TECHNICAL STAFF REPORT

MERRIWEATHER-SYMPHONY WOODS NEIGHBORHOOD

Planning Board Hearing of September 3, 2015

Case No.: PB 416

SCALE: AS SHOWN	DATE: JULY, 2015	SHEET 1 OF 4
-----------------	------------------	--------------

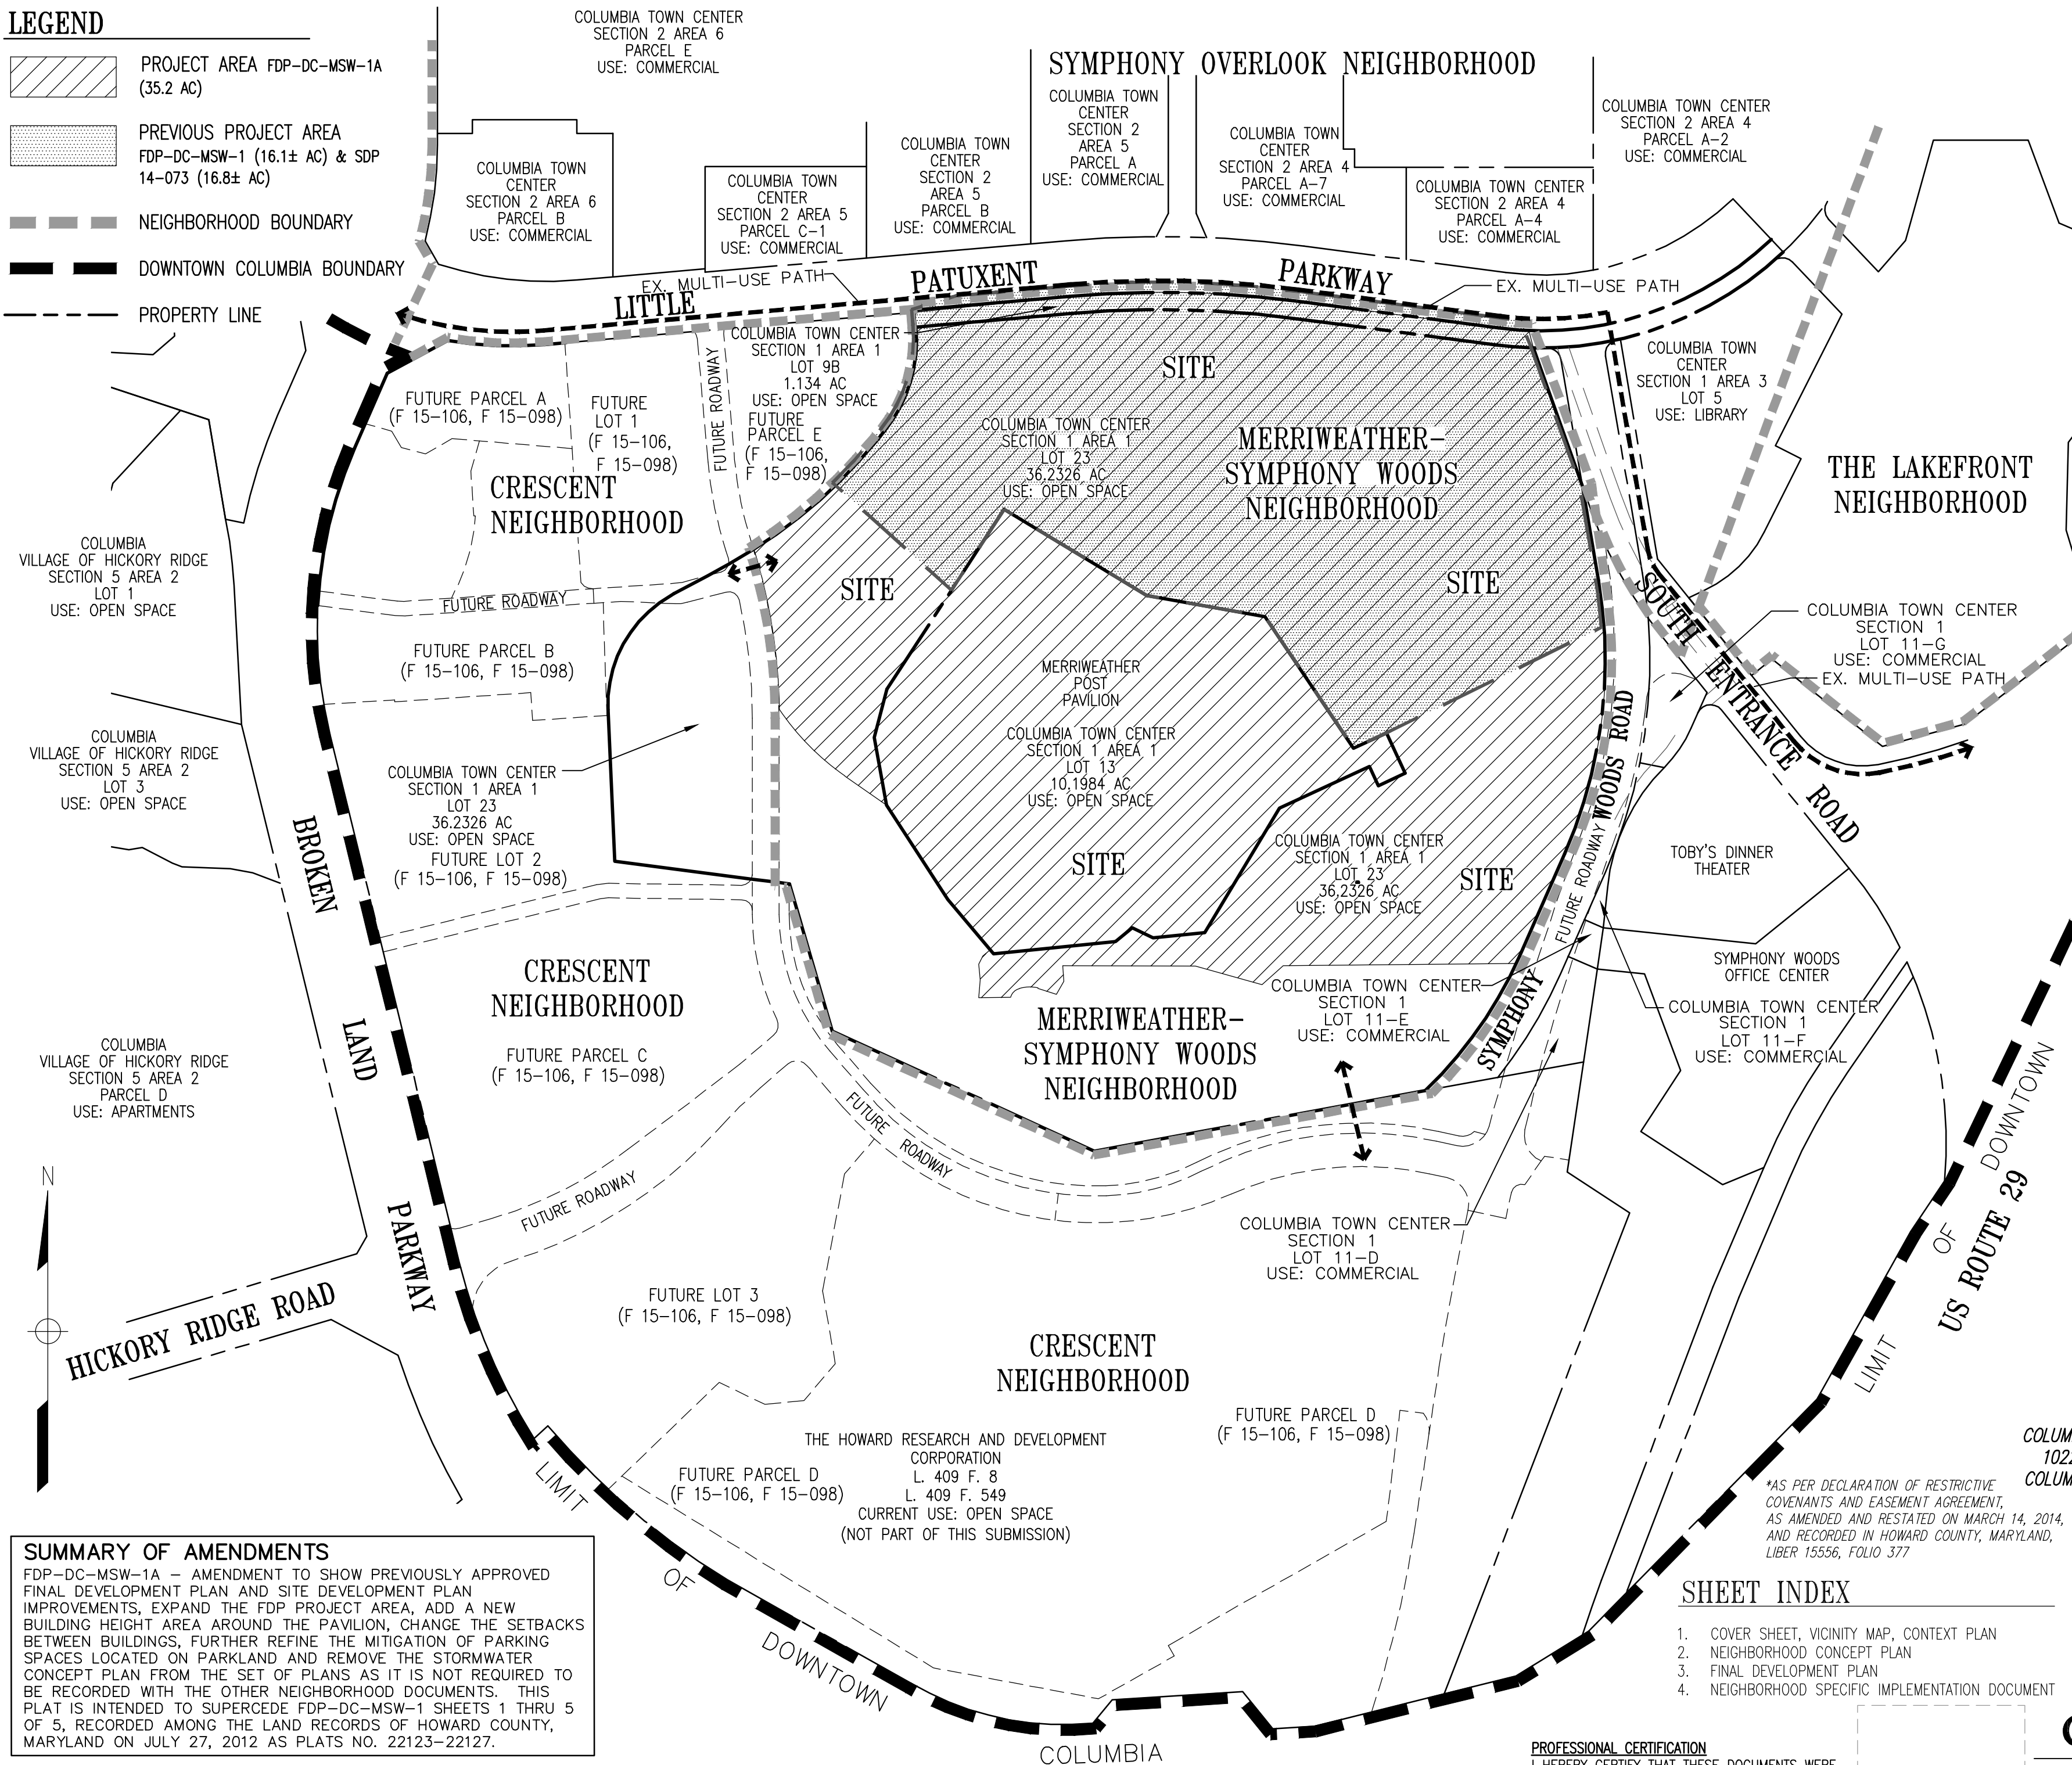
6. On Sheet 1, add to General Note 8, “The remainder of the structures within the FDP area shall not exceed 4 stories and 60 feet in height.”
- ~~7.~~ On Sheet 3, revise Note #6 to reflect the anticipated ownership, operation and maintenance of both the Symphony Woods property and the Merriweather Post Pavilion property as described in the Technical Staff Report, ‘Criterion n’.

SCALE: 1" = 100' DATE: JULY, 2015 SHEET 3 OF 4

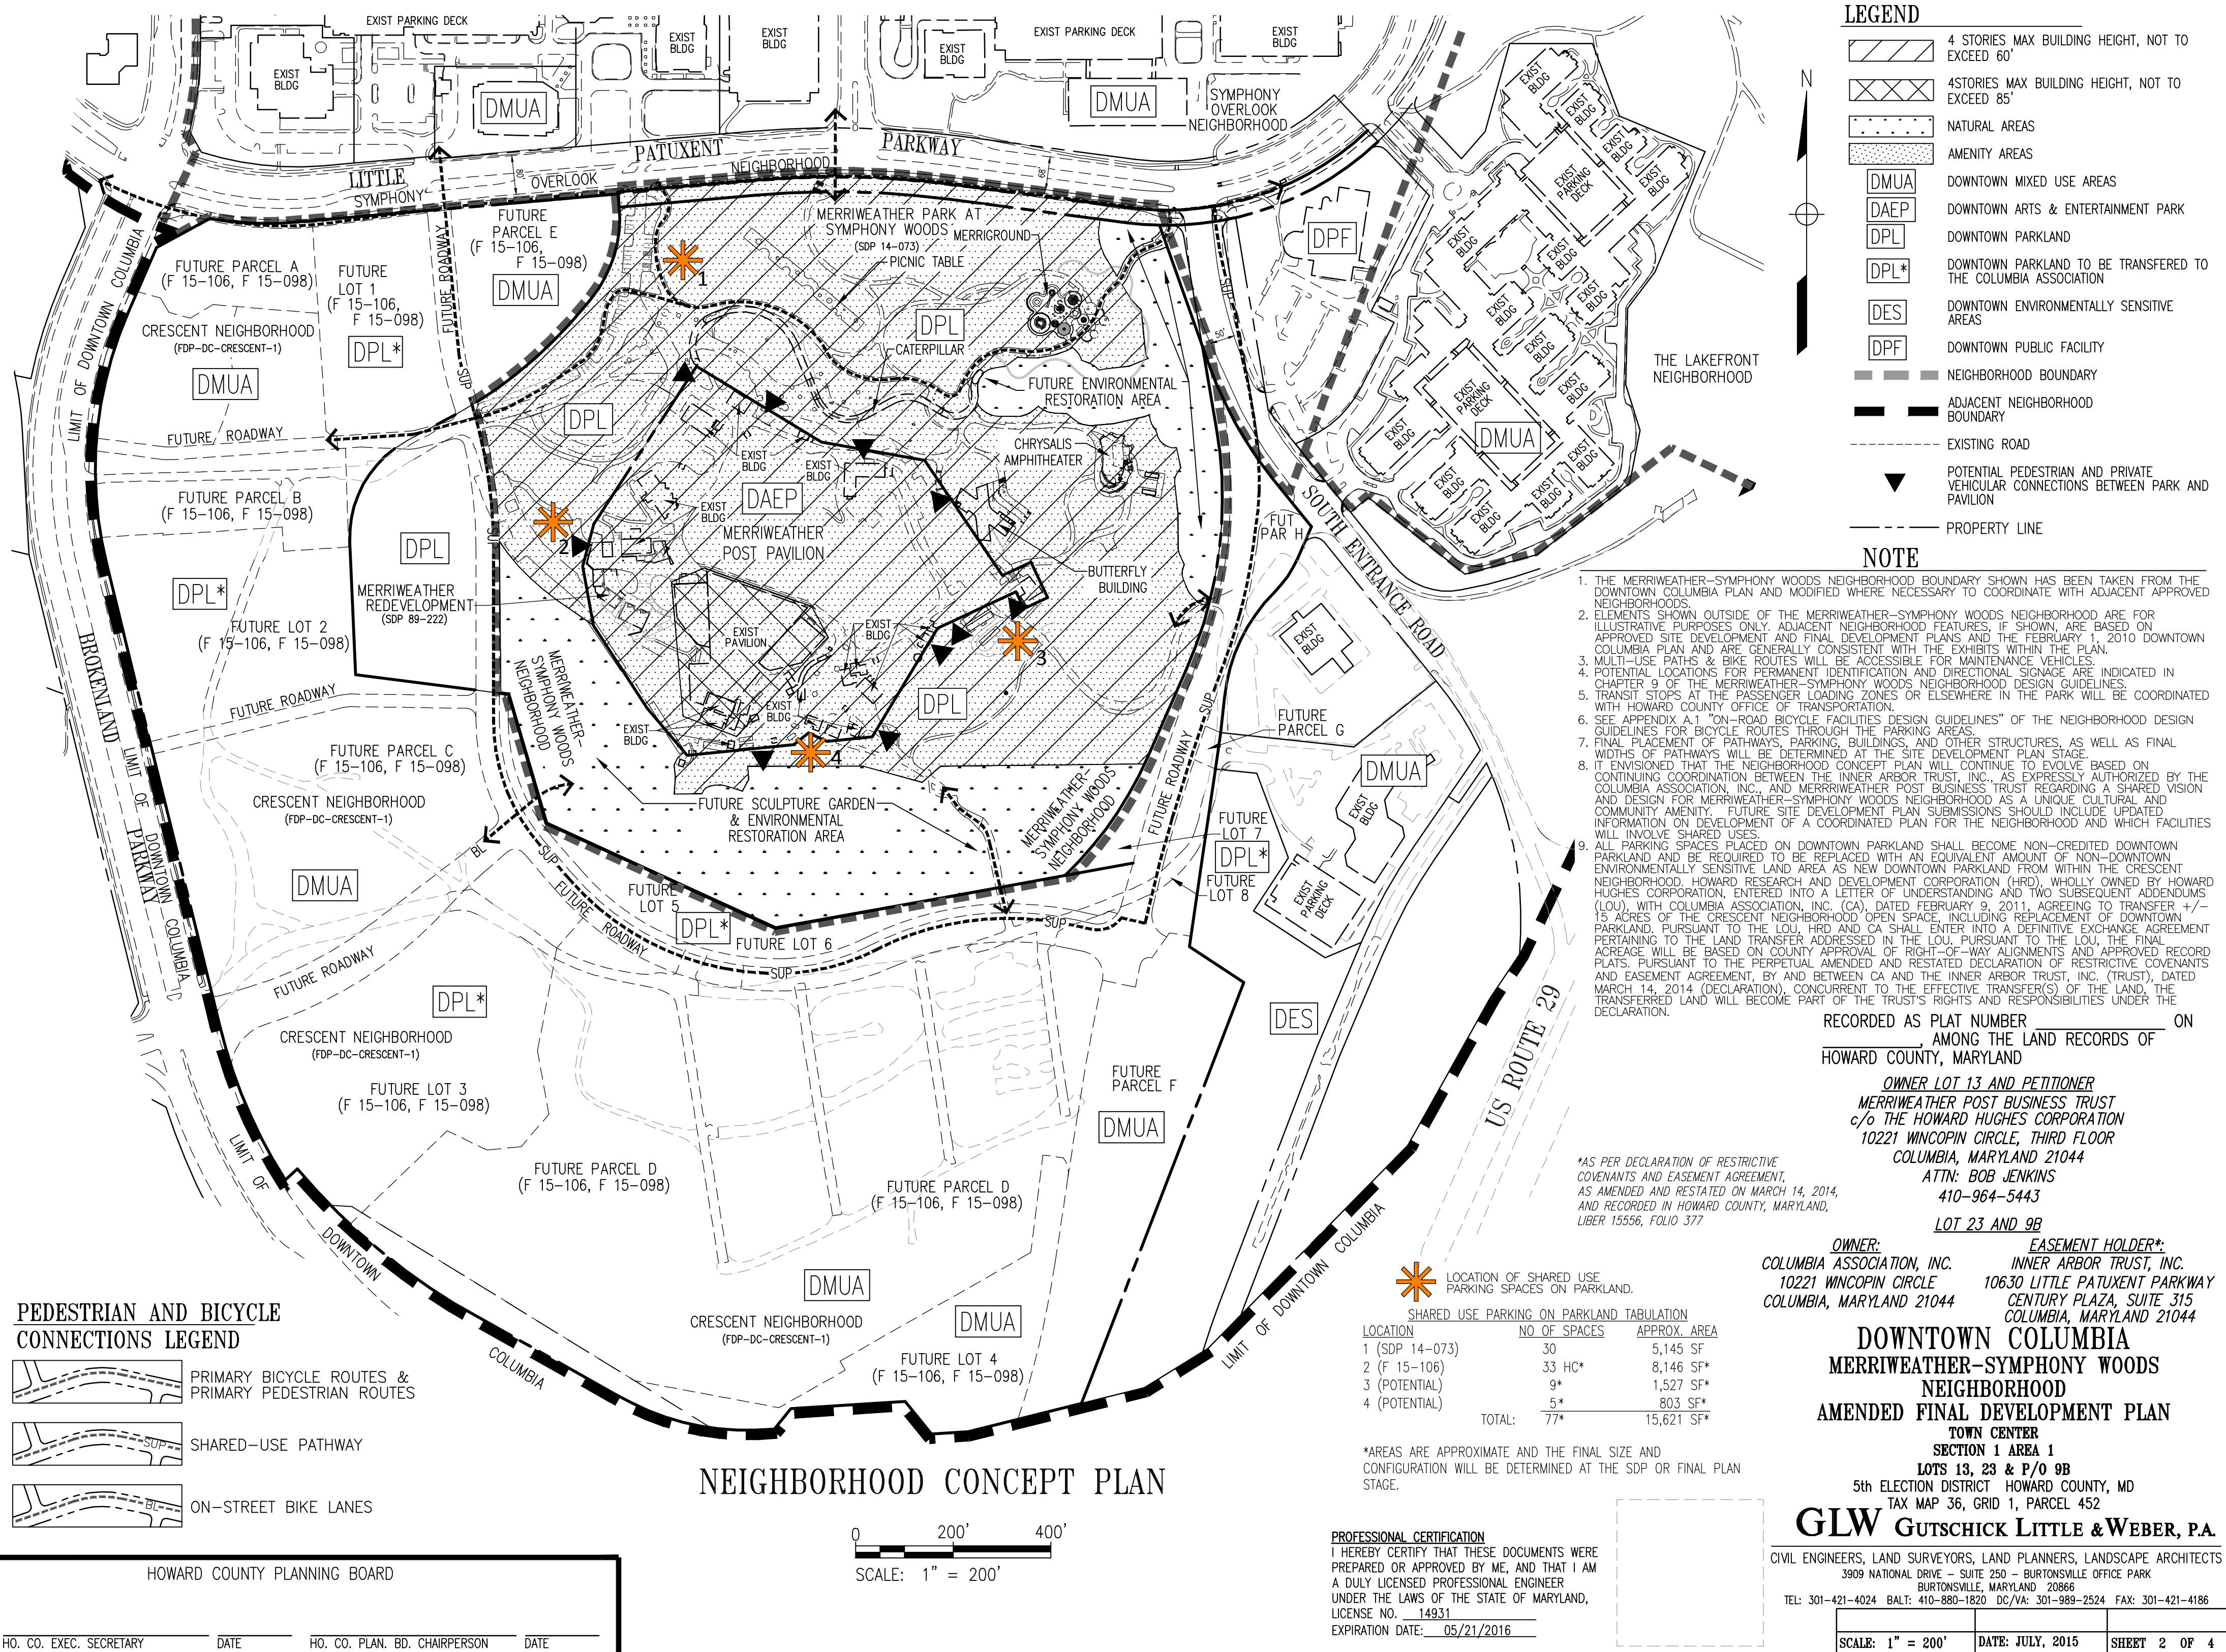
3. Delineate on the Neighborhood Concept Plan (Sheet 2) and Final Development Plan (Sheet 3) a major pedestrian connection between the Mall Entrance Crossing and the east-west major pathway that bounds the Caterpillar Plaza (as shown on SDP-14-073) as a major pedestrian signal is anticipated to be constructed at this location to facilitate crossing from the Mall and garage lots per SDP-14-073.

4. On Sheet 3, revise Note #3 regarding the preservation of a cultural significant building as provided in the response to comments dated July 29, 2015:

5. Provide a statement on the Final Development Plan (Sheet 3) explaining how this FDP amendment supports the completion of CEPPAs #16, #20, and #21 as provided in the response to comments dated July 29, 2015:

- ~~7.~~
8. On Sheet 3, revise Note #10 to state that Parkland replacement will be determined and transferred with the approval of the applicable Site Development Plan. Please also add a similar statement to item J regarding the Parkland Replacement on the Implementation Plan (Sheet 4).

“The Downtown Columbia Plan recognizes the importance of Merriweather Post Pavilion as a major community asset and anticipates its transfer to the Downtown Arts and Cultural Commission to assure its continued use as a performing arts center and premier regional concert venue. The Downtown Columbia Arts and Cultural Commission was created in 2013 as a charitable non-profit organization whose purposes include the promotion and support of the potential revitalization of Merriweather Post Pavilion in accordance with the Downtown Columbia Plan as an artistic and cultural center. CEPPA #24 requires Merriweather Post Pavilion to be transferred to the DCACC prior to issuance of a building permit for the 5,000,000 SF of development.”
